Sandwell Local Plan Regulation 19 Publication Draft Consultation

Sport England Representations

Appendix B, Mixed use allocations - SM2 (SA199) Lion Farm, Oldbury and policy SHW5

Figure 2 : Lightwoods Park

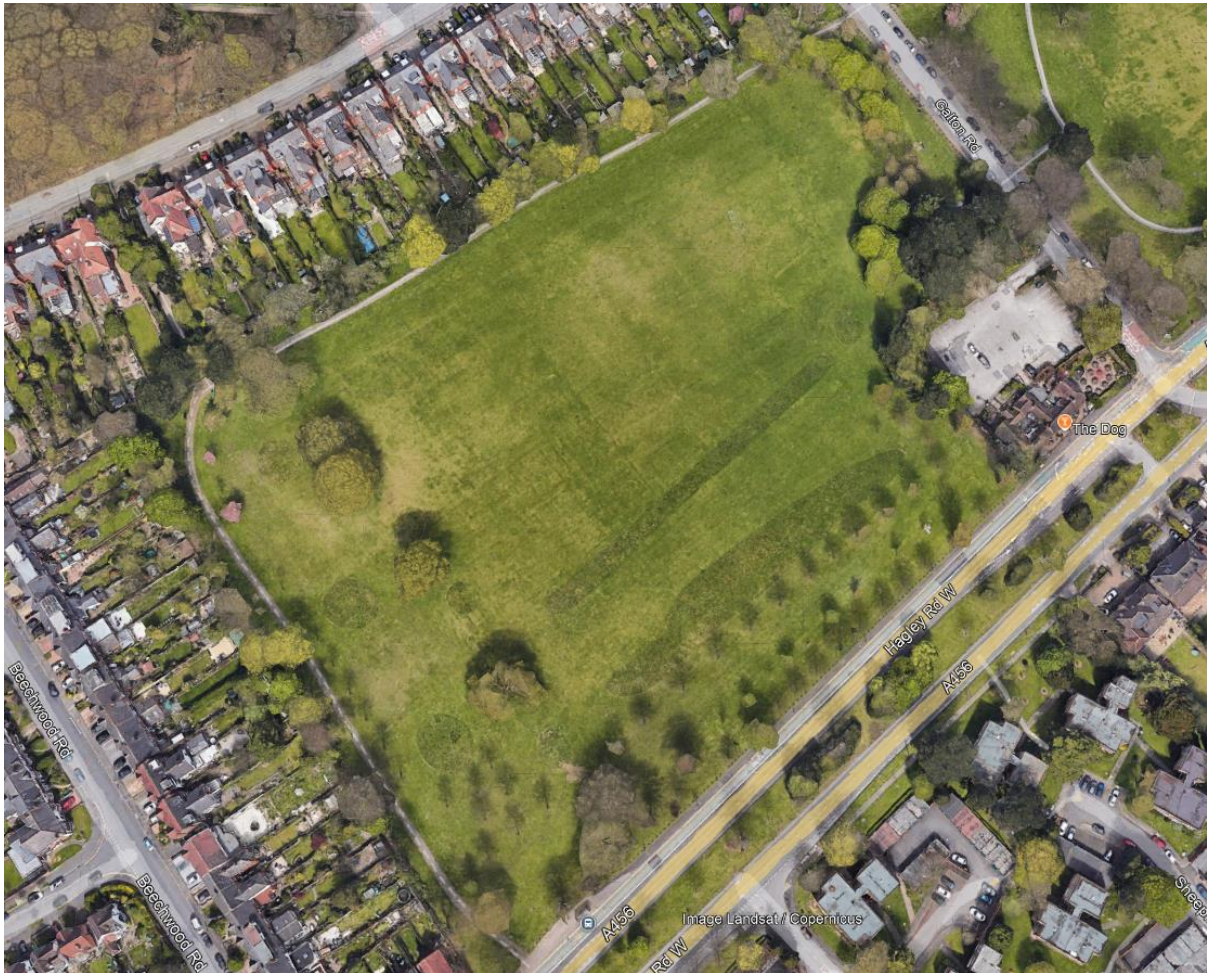
- No plan of the site is included to delineate the area of land intended to be used for replacement playing pitches. Sport England has assumed that the land in question is the area shown in the image below:

- The Council consider that the site could accommodate two adult pitches. It is unclear if the site could accommodate two full size pitches due to various constraints, including proximity to existing trees, neighbouring rear gardens and the A456, which would be likely to require high ball stop fencing along a prominent frontage to maintain balls within the field play. A full-size football pitch is 100m x 64m plus 3m run-off to meet FA recommended pitch sizes (so 106m x 70m overall). In our view, two full size pitches would be a very tight fit.

- In addition, the site already contains a non-turf cricket pitch (in good condition) (see Figure 2) in the northern part of the site, which practically constrains the capacity for adult football pitches to be provided in its existing location. This cricket pitch was

Lightwoods Park is incapable of providing equitable or better provision in quality and quantity, and does not provide a suitable location for replacement playing field provision, relative to the loss at Lion Farm. Provision of adult football pitches could displace the recently implemented non-turf cricket pitch.

Figure 7 : Black Patch Park in September 2011 – football pitches

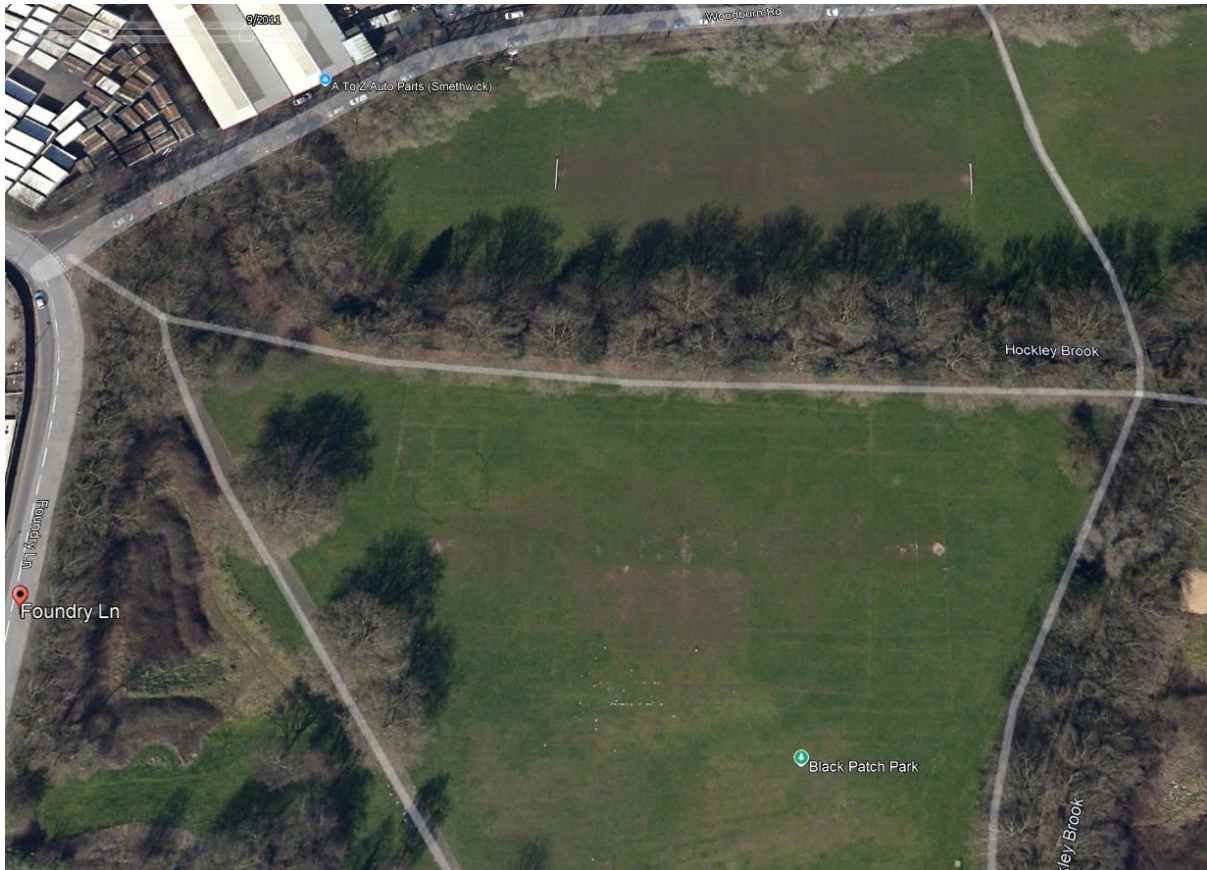
- There is evidence that the site has been used to provide playing pitches previously and so constitutes disused playing field (see image below). This would therefore not provide equitable replacement quantity since the land is already playing field.

- Black Patch Park is incapable of providing equitable or better provision in quality and quantity, and does not provide a suitable location for replacement playing field provision, relative to the loss at Lion Farm. The site constitutes existing playing field and so will not provide any quantitative replacement, and whilst the site has some potential to be brought back into use, the lack of ancillary facilities makes this unattractive to users. The site is also too small to accommodate adult pitches.
